MUL-T-LOCK®

NO. 218

DATE: 09.12.08

Modified spool pins – Special groove

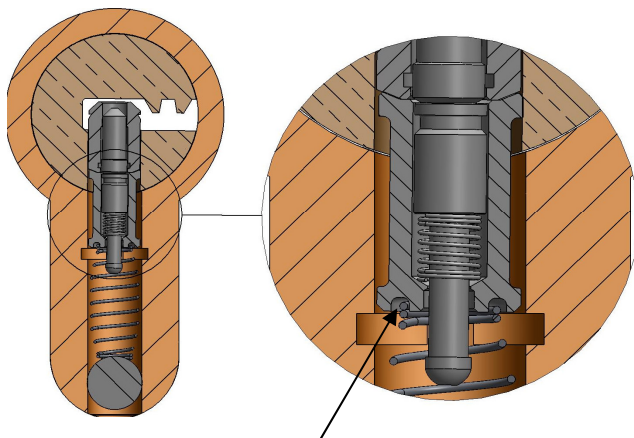
These pins work in conjunction with special groove we have added in chambers 3,4,5 in the cylinder body (published in the February & October 2008 news letters)

Cylinders equipped with this feature are identified by the letter I stamped next to the production code on the body.

Special groove in the pin

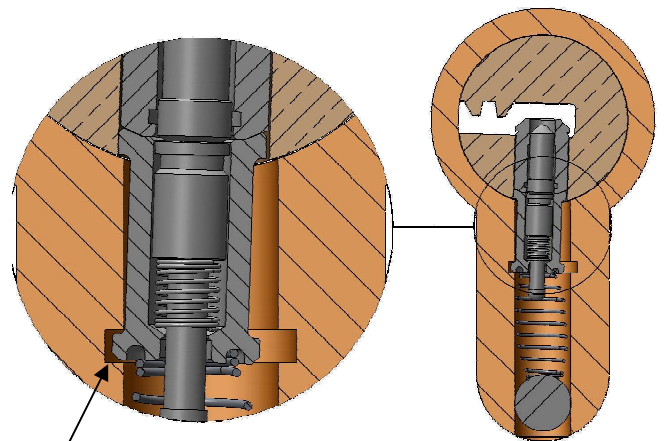
After launch we realized that in some cases the spring can move away from the pin into the chamber groove, causing the pin to get jammed.

In order to keep the spring in place and prevent the pin from jamming we have added a special groove to the pin bottom.

These modified pins are being assembled as standard since November 2008.

You can order these new pins (bag of 100) for servicing "I" stamped cylinders loaded with pre modified pins.

- Nickel Silver, Cat# 51215297
- Stainless Steel, Cat# 51057773
